SERVICE BULLETIN

SB-AG-88

660 TAIL GEAR ADAPTER BOX INSPECTION & REPAIR

Affected Aircraft Models	Serial Number Range
S2R-T660	ALL

Figure 1

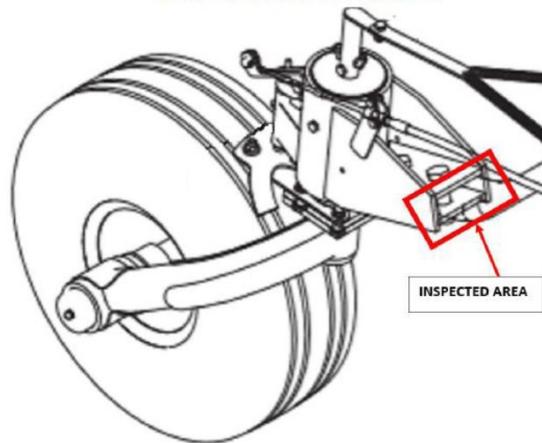
1. Locate forward end of tail gear adapter box and inspect for cracks and any other potential damage. (Reference Figure 1)

2. If cracks are detected, proceed in accordance with repair procedures outlined in following section.

Figure 2

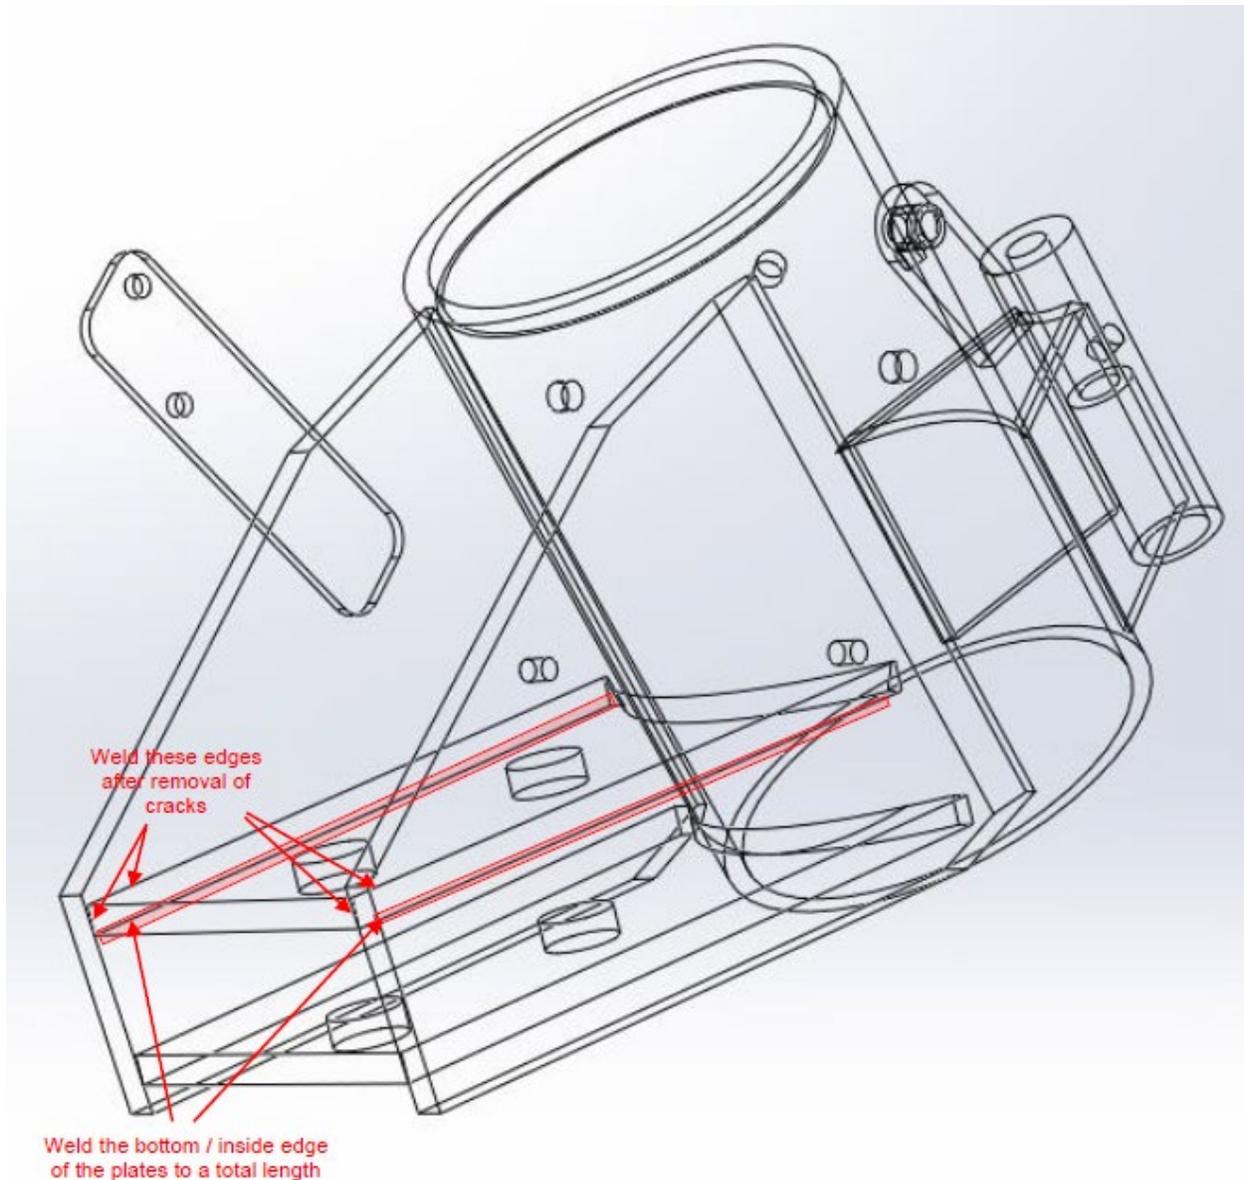
- Restore integrity of welds following accepted procedures. See Figure 2 for details of location of weld. Use MIL or equivalent spec.

NOTE: Acceptable to use International Standard ISO 15614-1 for welding part. Follow all guidelines of ISO for welding and WPQR (Welding Procedure Qualification Records).

Figure 3

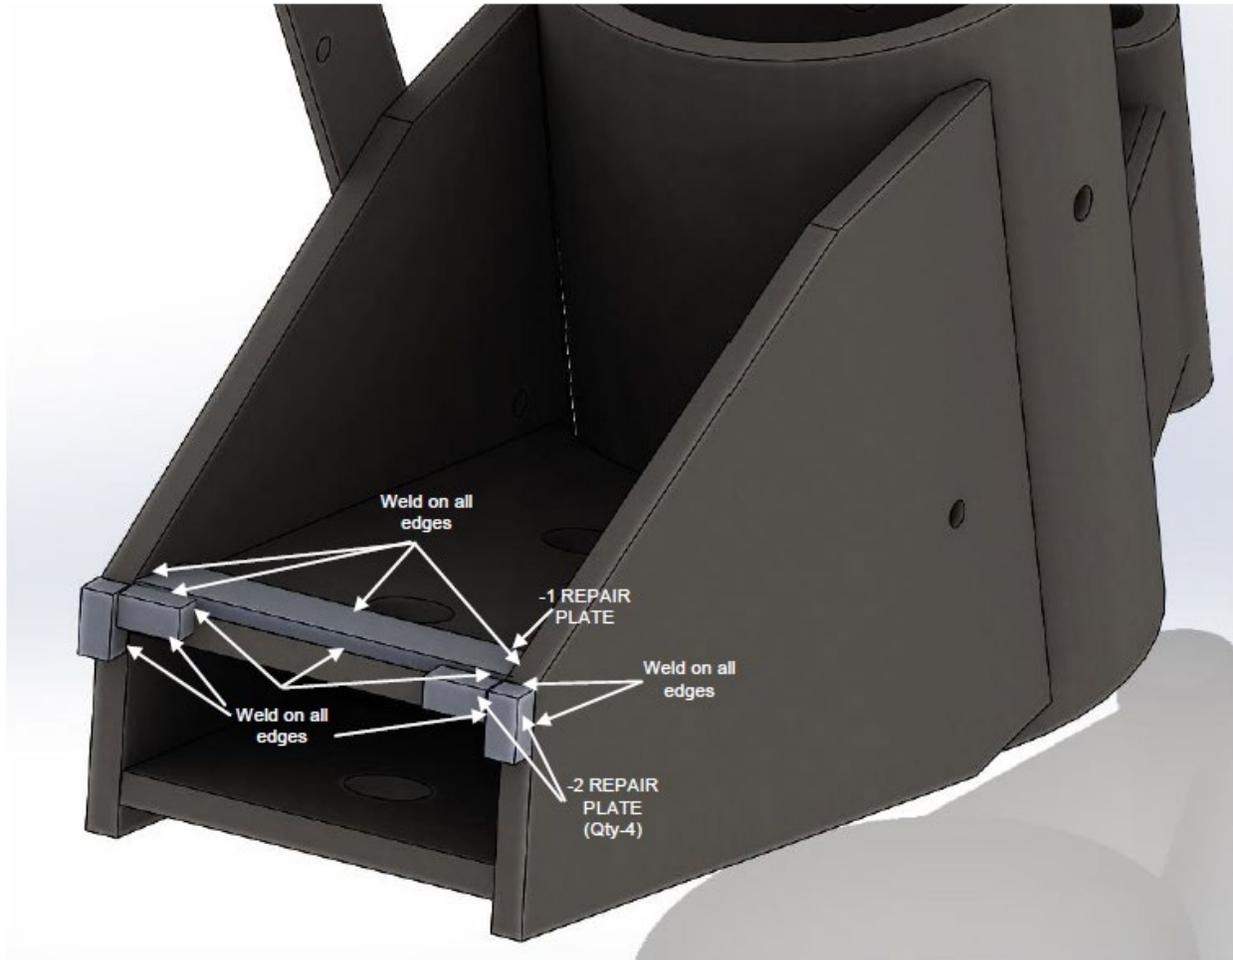
6. Weld -1 and -2 Repair Plates as shown in Figure 3 using accepted procedures. As/if required grind existing welds flush to existing structure during installation of -1 and -2 Repair Plates.

NOTE: Acceptable to use International Standard ISO 15614-1 for welding part. Follow all guidelines of ISO for welding and WPQR (Welding Procedure Qualification Records).
